APPEAL SUMMARY

Status: Decision Rendered - Reconsideration of ID 20402

Appeal ID: 20432	Project Address: 1534 N Blandena St
Hearing Date: 5/22/19	Appellant Name: Paul D. Wolfe
Case No.: B-014	Appellant Phone: 503-954-3065
Appeal Type: Building	Plans Examiner/Inspector: Geoffrey Harker
Project Type: commercial	Stories: 4 Occupancy: R-1, R-2 Construction Type: V-A
Building/Business Name: Overlook 8 Motel	Fire Sprinklers: Yes - NFPA 13 Throughout
Appeal Involves: Alteration of an existing structure, Reconsideration of appeal	LUR or Permit Application No.: 19-122517-CO
Plan Submitted Option: pdf [File 1] [File 2]	Proposed use: Apartment Housing / Motel (transient)

Overlook 8 Motel
 1534 N Blandena Street, Portland, OR 97217

Building Section
E-W

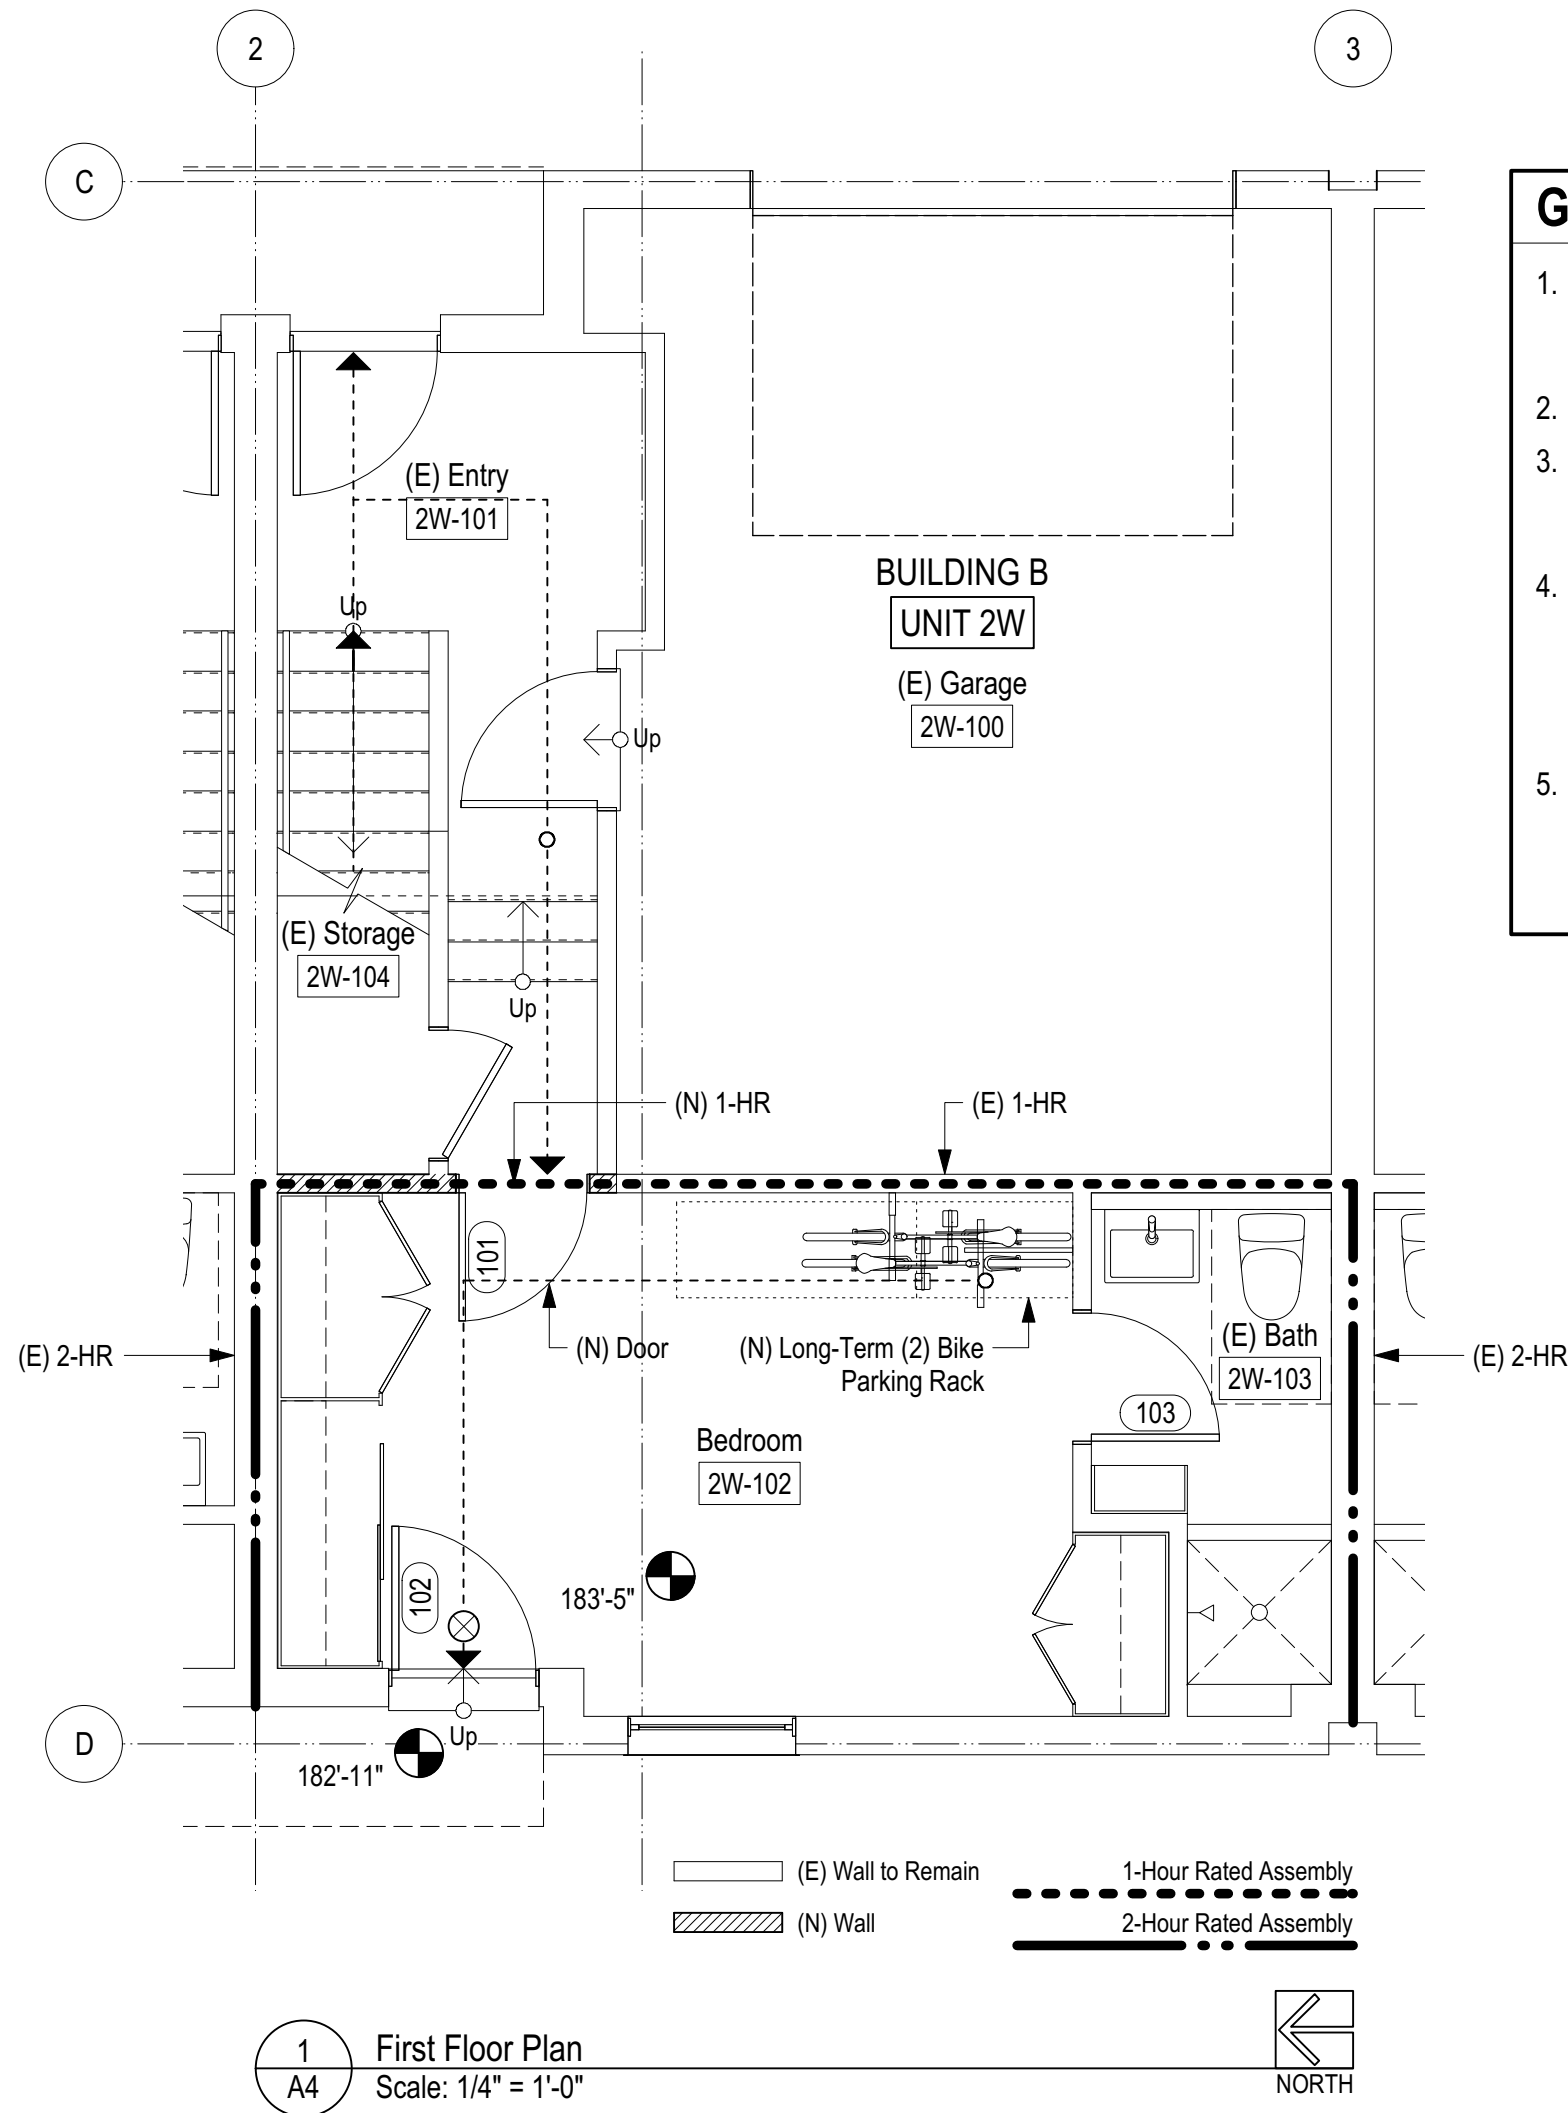
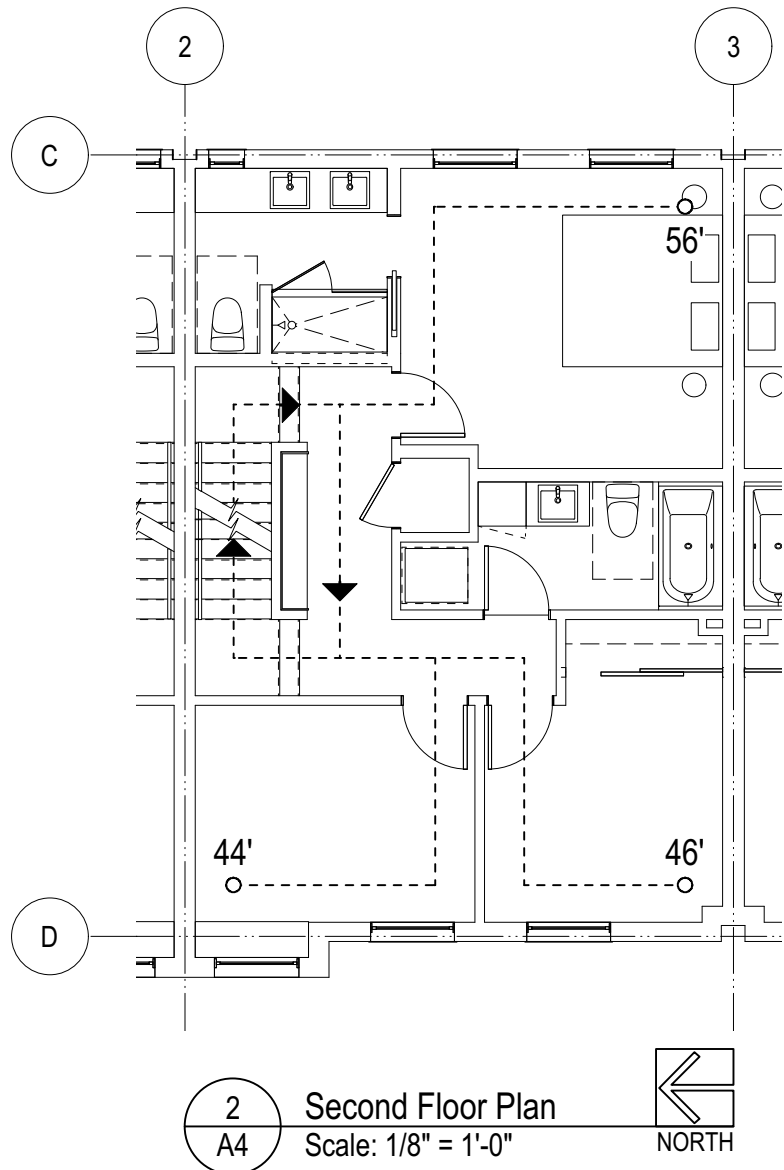
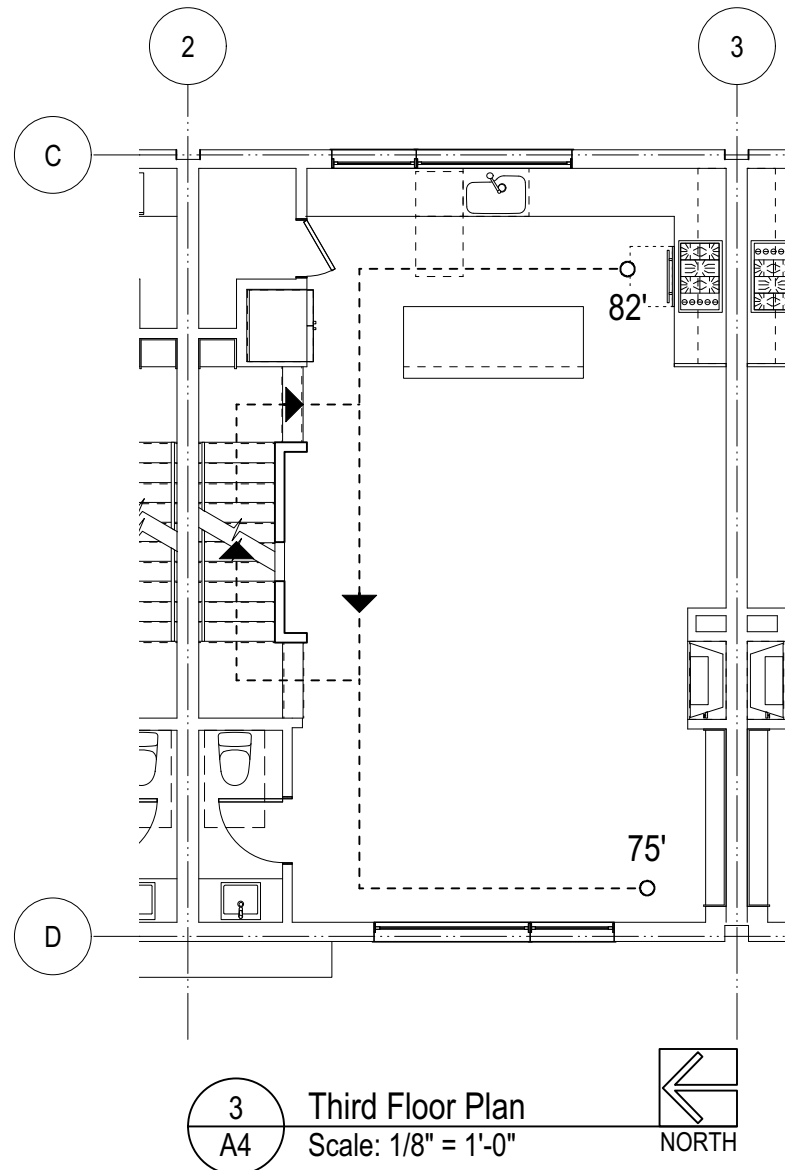
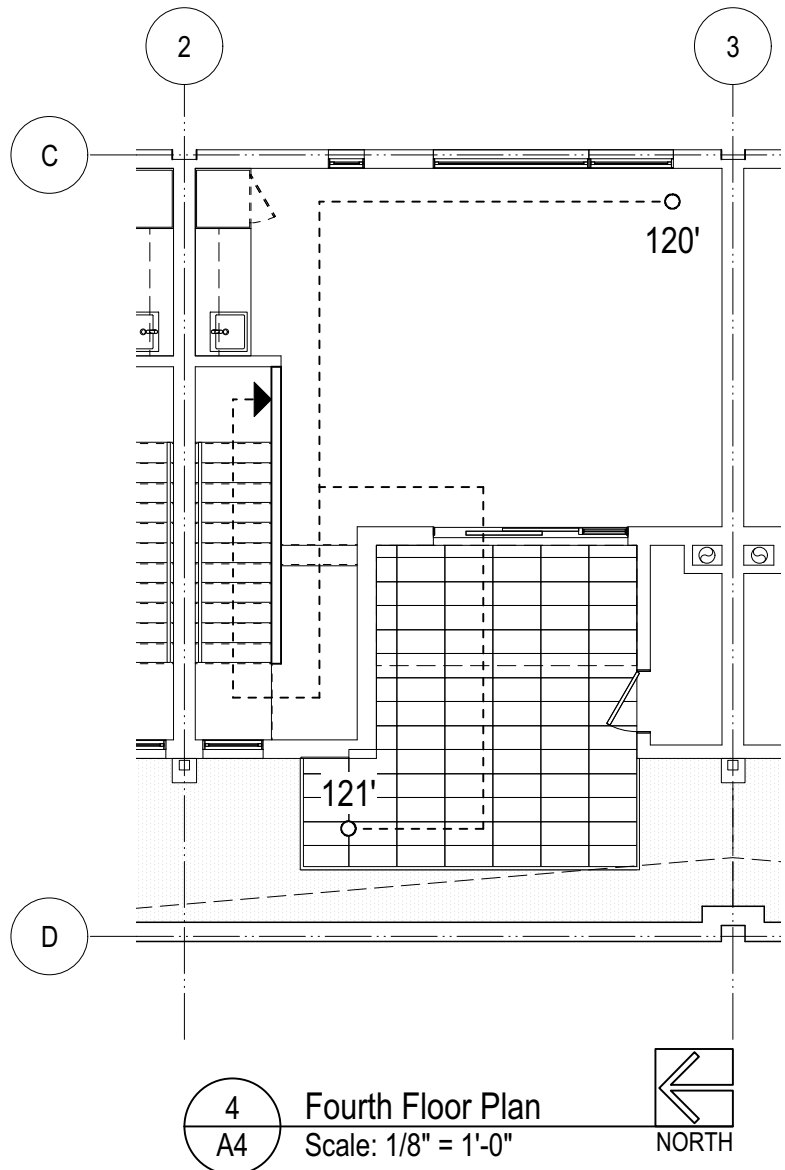
One exit path exits out the eastern “front” door into the center drive court. The second path of egress shall be through the adjacent R-1 transient occupancy unit to the exterior. Door 101 separating the R-2 and R-1 occupancies will be an Access Controlled Egress Door with an Asylum Latch and Fail-Safe electronic lock with ETW Hinge interconnected to the building fire alarm, in compliance with NFPA 101 Section 7.2.1.6.2. The door will be of 1-hour construction and will be equipped with hardware connected to the fire alarm with a sign stating, “EMERGENCY EXIT – Door will open in the event of emergency.” Functions of the door will be as follows;

The door hardware function will be locked from either side at all times until the building fire alarm is triggered; no operable hardware is proposed on the R-1 side of the door (static lever or cover plate). A direct path of egress is provided from door 101 to door 102 and emergency egress lighting of a minimum of 1 fc is provided. Door 102 will be equipped with an exit sign.

Second exit from 4 story townhouse through separate R1 unit: Denied. Proposal does not provide equivalent Life Safety protection.
